Docket Number:	21-BSTD-01
Project Title:	2022 Energy Code Update Rulemaking
TN #:	238386
Document Title:	Southern California Gas Company Comments - SoCalGas Comments on the Proposed Changes to the 2022 Energy Code Update Rulemaking
Description:	N/A
Filer:	System
Organization:	Southern California Gas Company
Submitter Role:	Public
Submission Date:	6/21/2021 3:58:30 PM
Docketed Date:	6/21/2021

SoCalGas Comments on the Proposed Changes to the 2022 Energy Code Update Rulemaking

Subject: Comments on the Proposed Changes to the 2022 Energy Code Update Rulemaking

Figure 1: Capacity Value Forecast

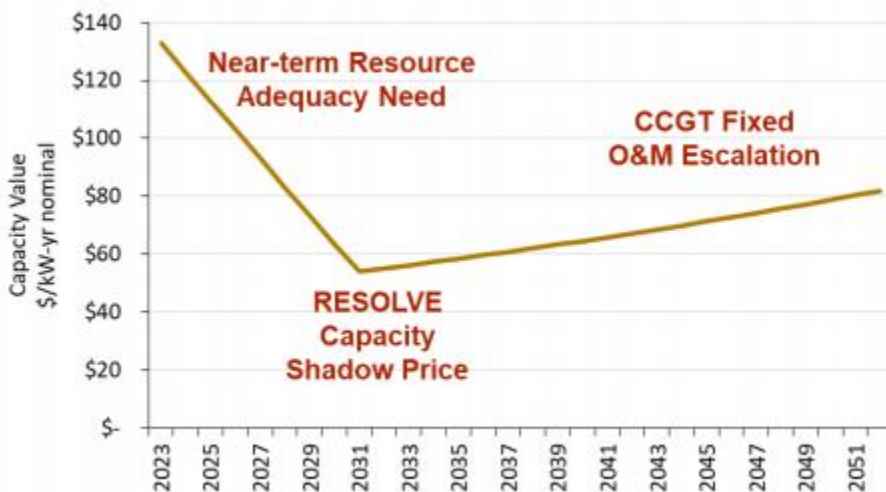
Likewise, we note that the gas supply costs associated with the operation of the combined cycle gas turbine (CCGT) resources are likely understated. According to the CEC analysis, the cost of the CCGT assets is constant in real terms after 2031 as indicated in Figure 1.⁸

However, this assumption is at odds with the need to maintain the means by which CCGTs obtain fuel (the gas transportation and distribution networks) over the same period during which throughput and distribution customer count are projected to decrease. In practical effect, CCGTs will be bearing more of the gas system costs (including for firm transportation service) with fewer units of electricity production, which will result in a corresponding increase in the costs for electricity and output. Because gas throughput will decline and infrastructure costs will not decline commensurately, the electricity prices from CCGT will not remain constant after 2031 but will likely increase. Please see Appendix C for additional detail.

Figure 2. Scenario with Equal Maintenance Cost for Gas Instantaneous and HPWH

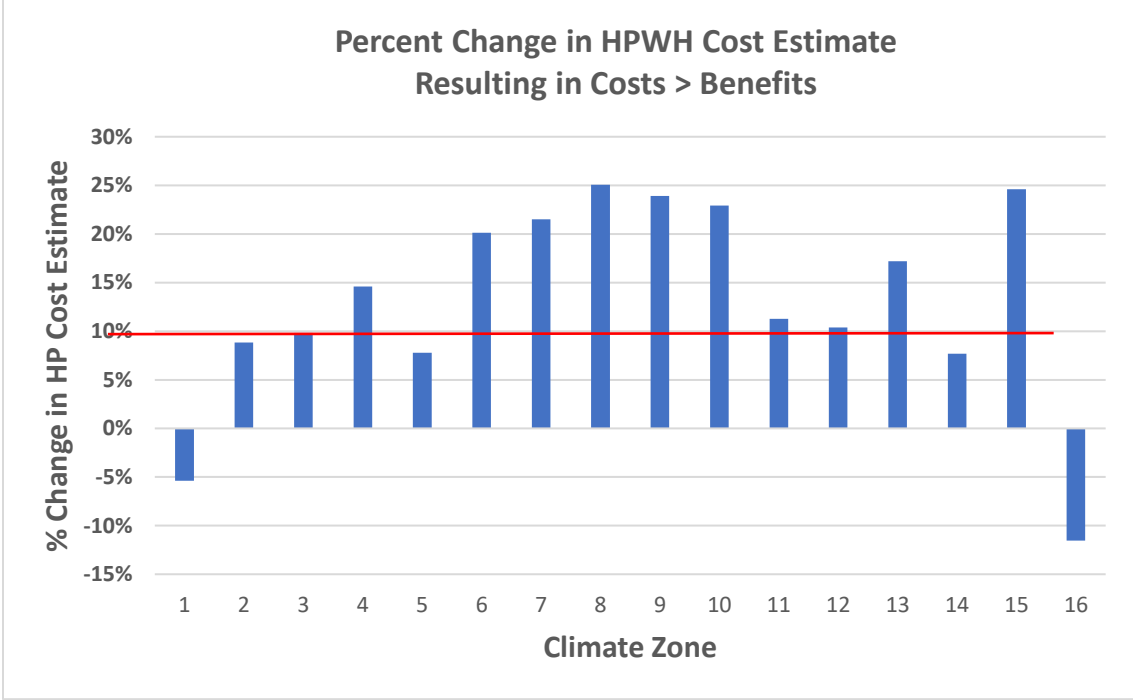
Additionally, SoCalGas ran some sensitivity analysis to check the variations in incremental cost (on top of the maintenance cost addition) that would impact the cost-effectiveness of these technologies. The results are shown in 2, which shows the percent change in HPWH cost that would result in the total cost exceeding the total long-term benefits offered by this technology, in each climate zone. As is clear from the Figure 2, a 10 percent increase (indicated by a red horizontal line) in the cost of a HPWH could potentially result in overall higher costs than benefits in several of the climate zones. Climate zones 1 and 16 show they are already not cost effective using the same maintenance costs, but with an increase of 10 percent maintenance costs climate zones 2, 3, 5, and 14 are also no longer cost-effective. Uncertainty in other variables, including the TDV values for natural gas and electricity could result in changes in the economic balance in additional climate zones. We also want to point out that incremental costs can vary widely based on factors such as location, contractor, installation scenario as well as customer behavior, which has a significant impact on the actual incurred maintenance cost and can vary from customer to customer.

Figure 3. Natural Gas Price Projections Over Time as a Factor in Commodity Costs

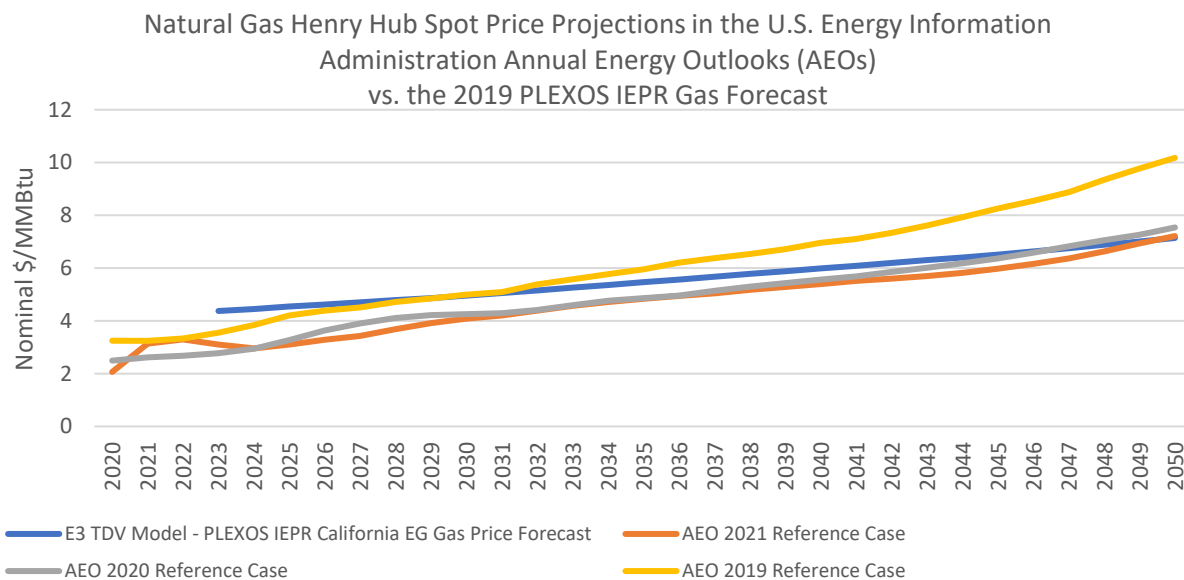
SoCalGas believes that the natural gas commodity prices were overestimated due to the use of an outdated natural gas price forecast. For instance, the CEC consultants Energy + Environmental Economics (E3) used the PLEXOS Integrated Energy Policy Report (IEPR) California EG Natural Gas Price Forecast (Nominal \$/MMBtu) for 2019. As SoCalGas does not have access to the PLEXOS Forecast for 2019, we compared the U.S. Energy Information Administration (EIA) Annual Energy Outlook (AEO) values for 2019, 2020, and 2021 to estimate the decline in gas price outlook between 2019 and 2021.^{23,24} As shown in Figure 3, we found that, on average, the 2019 AEO overestimated natural gas spot price projections (in nominal dollars/MMBtu) at Henry Hub by 20 percent compared to the 2020 AEO, and by 21 percent compared to the updated 2021 AEO. Meanwhile, the 2019 PLEXOS forecast was 11 percent higher on average than the 2020 AEO forecast and 14 percent higher on average than the 2021 AEO forecast. Older gas price projections tend to overestimate prices relative to more recent studies. The commodity price of natural gas is just one of five inputs, but an overestimate of about 20 percent in the commodity price, coupled with a huge increase in the retail adjustment and an unverified “emissions abatement” cost can result in price factors that are unreliable and excessively inflated.

The projection of natural gas prices for the Proposed 2022 California Energy Code update reflects a dramatic increase, about 33 percent, in the consumer gas prices relative to the 2019 forecast. More than half of this increase is due to an increase in the retail rate adjustment. The retail rate adjustment by itself represents the single largest component of the potential gas cost accounting for more than 40 percent of the total gas costs. The retail rate adjustment is based on a utility cost allocation reflecting a significant

Figure 4. 2019 vs 2022 Natural Gas TDV

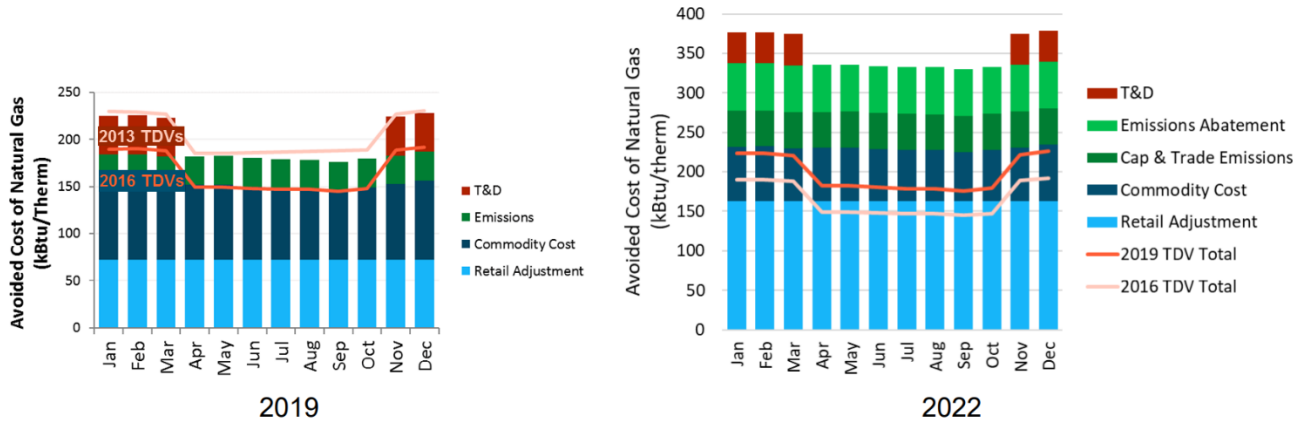
goes from about \$70 of avoided cost of natural gas (kBtu/Therm) in the 2019 forecast to \$160 of avoided cost of natural gas (kBtu/Therm), which is an increase of about 225 percent.

Figure 5. E3's Comparison of the Hydrogen Price Estimates in the MHPS Study (June 2020) and in the CEC Retail Gas Study (April 2020)³⁵

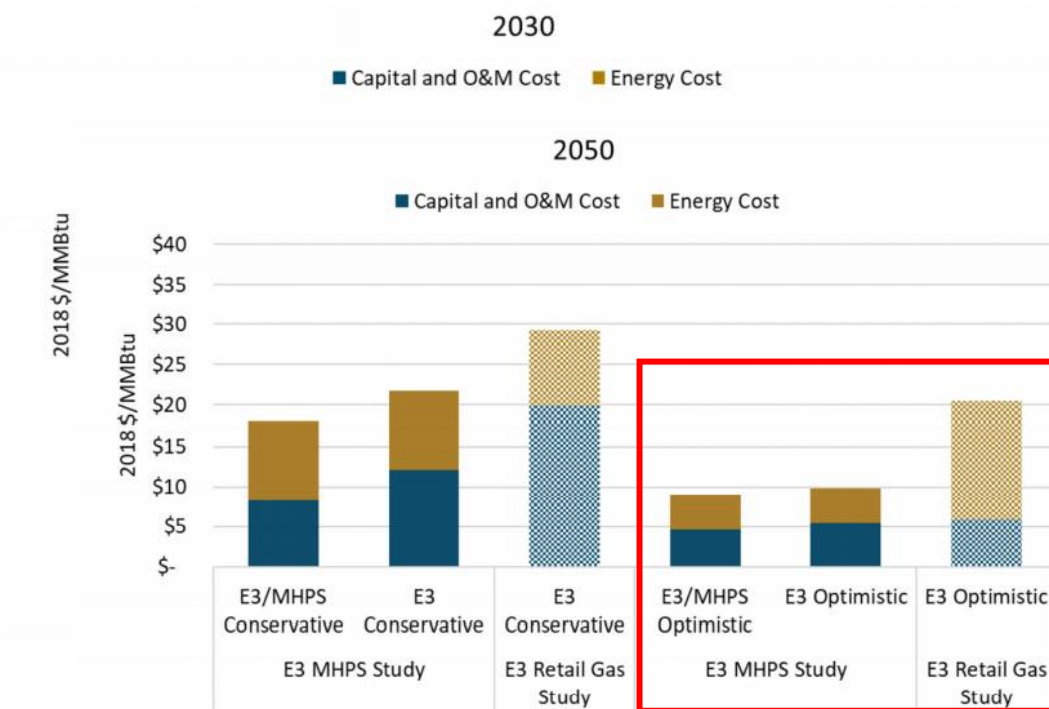
While the contemporaneous E3 study³² did not reflect the CEC views and is based on a different set of assumptions developed for a different client with a different perspective on the market, SoCalGas believes that at a minimum, the CEC analysis should recognize variations among hydrogen price forecasts and that used in the TDV (suggesting that it reflects a somewhat conservative projection of future costs). As such, assessment and consideration of additional scenarios more in line with current industry expectations would enhance the efficacy and accuracy of the analysis. For instance, during the same time period, other public reports³³ projected that delivered hydrogen costs would fall to \$15/MMBtu by 2030 and to \$7.4/MMBtu by 2050, if a significant public investment in hydrogen technology is made. Furthermore, the U.S. Department of Energy (DOE) recently announced a “Hydrogen Energy Earthshot” program that presents a hydrogen production cost target of about \$7.4/MMBtu by 2030.³⁴

Figure 6: Indoor PM_{2.5} and NO₂

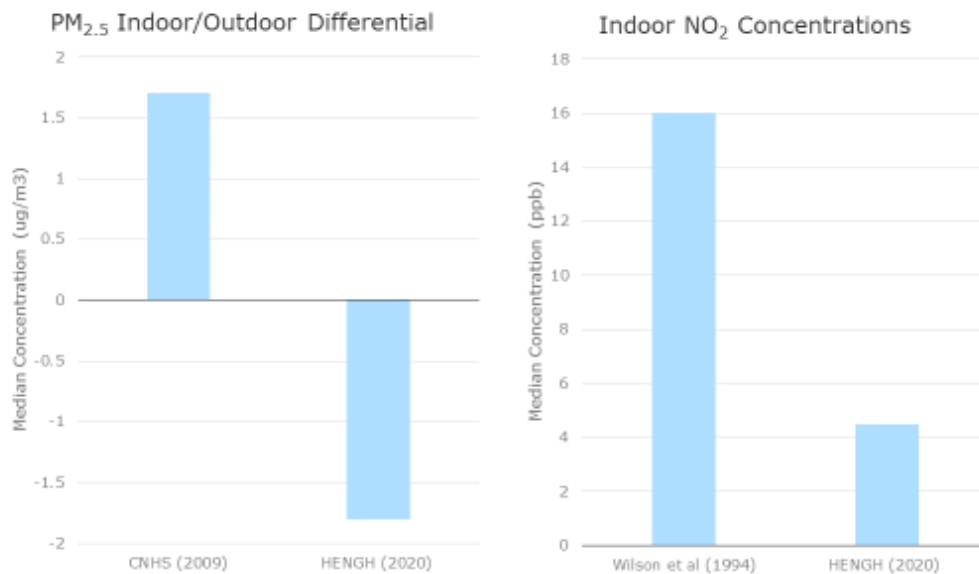
Finally, as illustrated below in Figure 6,^{50,51,52} indoor PM_{2.5} and NO₂ concentrations have been decreasing. Thus, residential exposures to air pollutants from gas appliances are decreasing and are much lower now than 20 years ago. PM_{2.5} emission reduction drivers are lower outdoor PM_{2.5} emissions, high efficiency air filters in central forced air systems and mechanical ventilation systems. NO₂ emission reduction drivers are mechanical ventilation and lower outdoor NO₂ emissions.
